FS3-12

703.2.3

Proposed Change as Submitted

Proponent: Tony Crimi, A.C. Consulting Solutions Inc, representing North American Insulation Manufacturers Association (NAIMA) (tcrimi@sympatico.ca)

Fig. 2

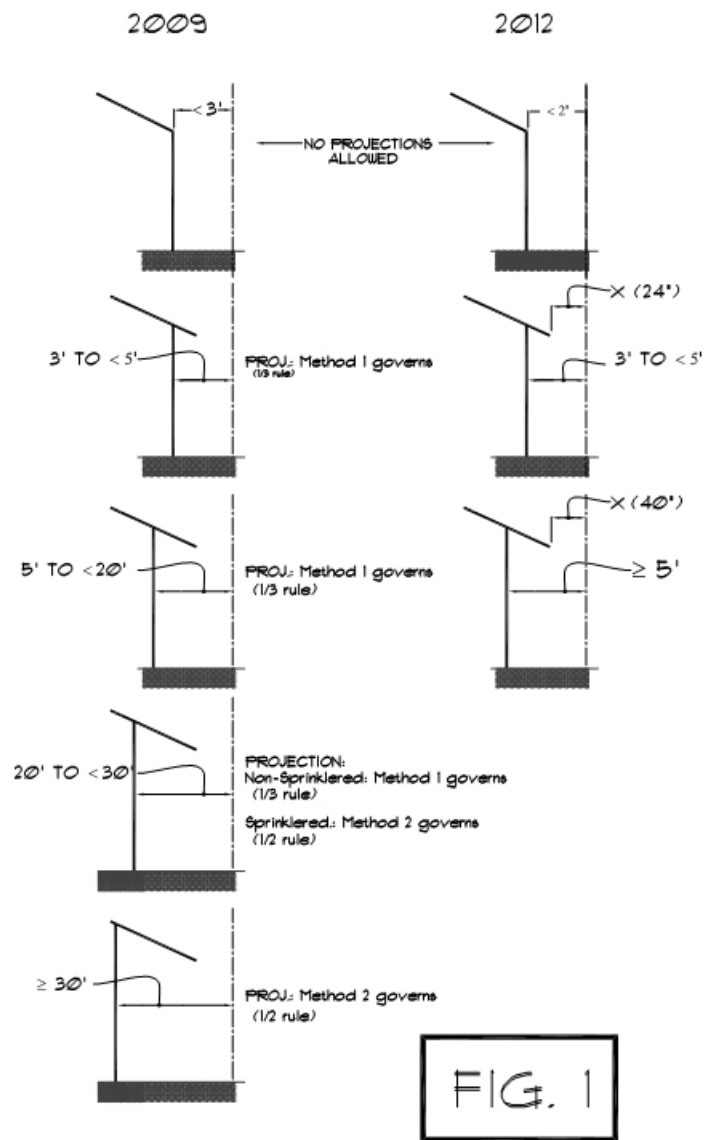
In Table 705.2, the third row is where the flaw appears. For example, if the FSD is 4 feet, then the minimum distance for projection to FSD is 24 inches. That means the maximum allowable projection can be 24 inches (48" – 24"). On the other hand, if FSD is 5 feet, then the minimum distance from the line used to determine FSD is 40". That means that projection can only be 20" (60" - 40"). Less projection is allowed for 5' FSD than 4' FSD!! This is clearly shown in Fig. 2. Also Fig. 3 shows this flaw and at the same time 2009 and 2012 have been compared graphically.

The new proposal still maintains the simplicity that is introduced in 2012 along with incorporating 2009 numbers.

Figure A – Large cantilevered balconies permitted by

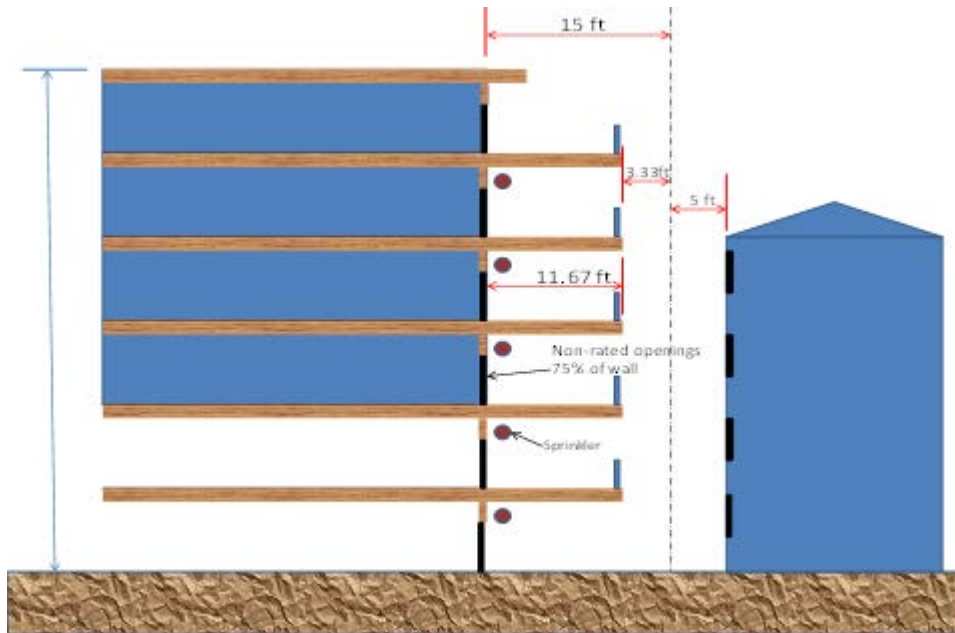
Figure A shows the results of applying the 2012 IBC to a 5 story Type IIIA fully sprinklered residential building with cantilevered balconies. Figure B shows the results of applying the 2012 IBC to a multi level restaurant with exterior dining. Figure C shows the desired outcome of the code change.

Figure 3: Top-gates of the Tree annotated with the intent of IBC §713.14.1

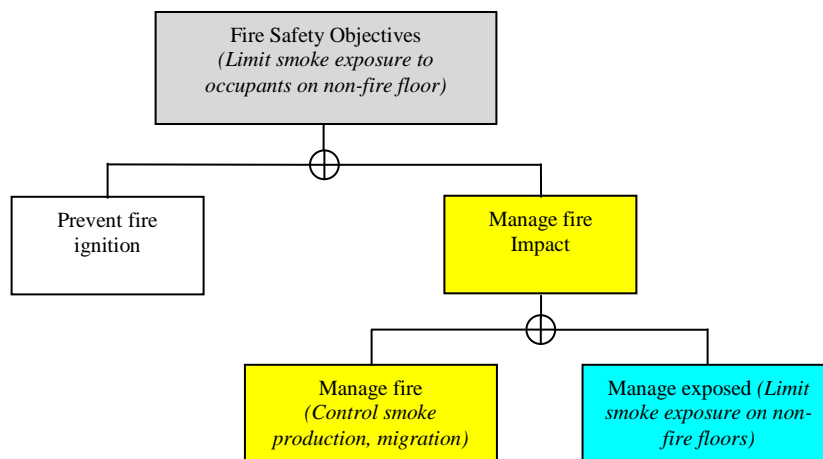
As noted, elevator lobbies required by Section 713.14.1 are intended to limit smoke exposure to occupants on non-fire floors. Figure 3 illustrates the top tier gates of the *Tree* to accomplish that objective. The building code assumes the fire occurs, thus, the driving objective is to "manage fire impact" by "manage the fire" or "manage exposed."

Figure 4: IBC 2012 required features and systems that contribute to limiting smoke production and migration to non-fire floors.

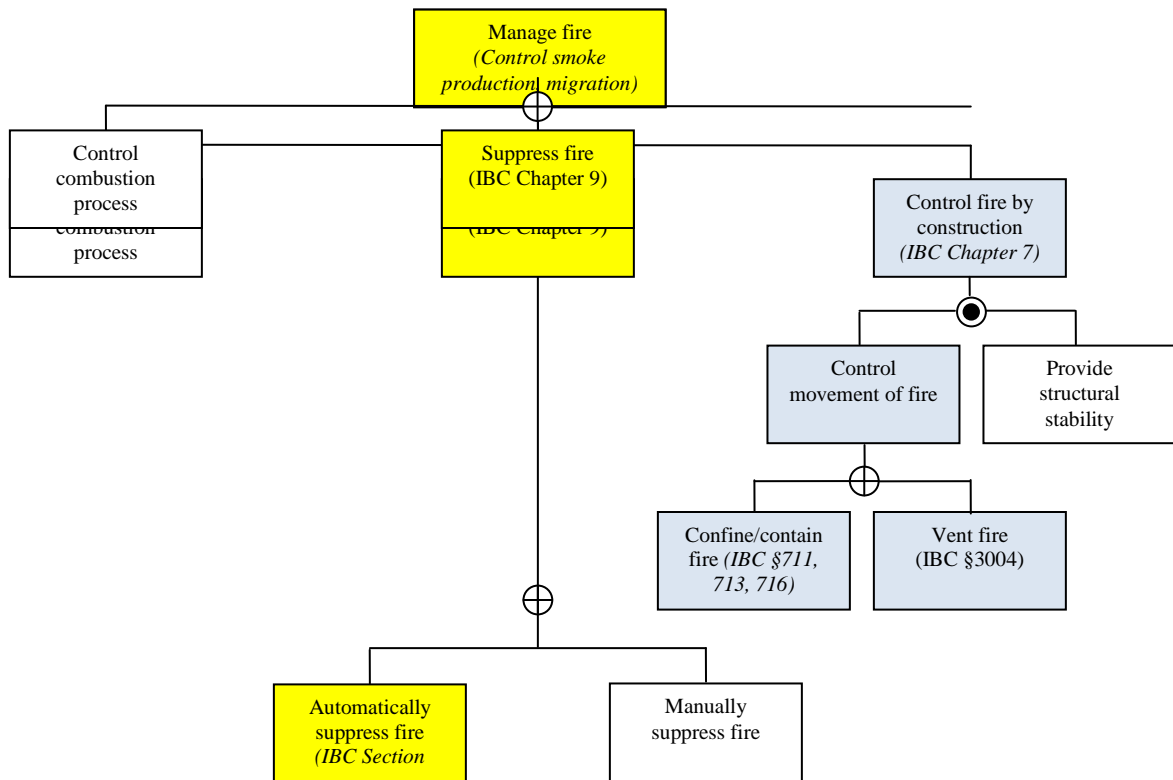
Figure 4 illustrates the two or three possible options to achieve “manage fire.” Suppressing the fire by an automatic fire sprinkler system installed in accordance with IBC Chapter 9 or controlling fire (vertical migration) by construction features in accordance with IBC Sections 713 (shafts), 711 (horizontal assemblies), 716 (opening protectives) or venting fire/smoke that infiltrates into the elevator shaft in accordance with Section 3004 are each ways to limit the smoke exposure to occupants on non-fire floors. Controlling the combustion process, while identified as an option that can be used in general and used to a limited extent by the IBC’s requirements for interior finish, is not practical or sufficient to solely achieve the objective in a building.

Figure 5: IBC 2012 required features and systems that limit smoke exposure to occupants on non-fire floors.

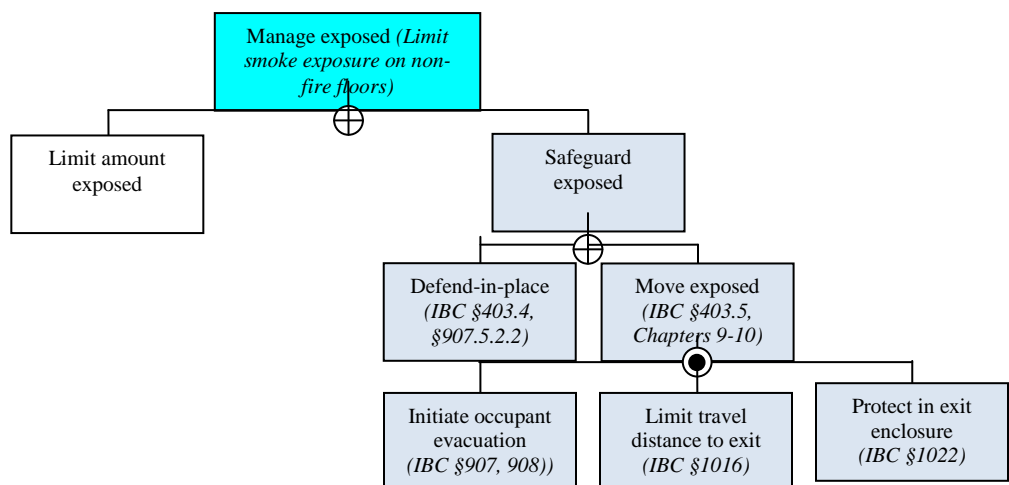
Figure 5 illustrates the options to achieve “manage exposed.” “Safeguard exposed” is accomplished by “defend-in-place” and “move exposed.” IBC Chapter 9 and Sections 403.3 and 403.4 require various fire safety systems to detect and alert the building occupants of a fire condition and to initiate evacuation. The provisions of IBC Chapter 10 and Section 403.5 both require various fire safety features and systems to protect the building occupants during egress or evacuation, thus limiting smoke exposure to occupants on non-fire floors. Section 403.2.3 requires egress stair and elevator hoistway enclosures in Risk Categories III and IV high rise buildings (Table 1604.5), and all buildings over 420 ft in height to exhibit impact resistance that resists the passage of fire and smoke into the shafts, minimizing the potential for inadvertent compromise of the enclosure.
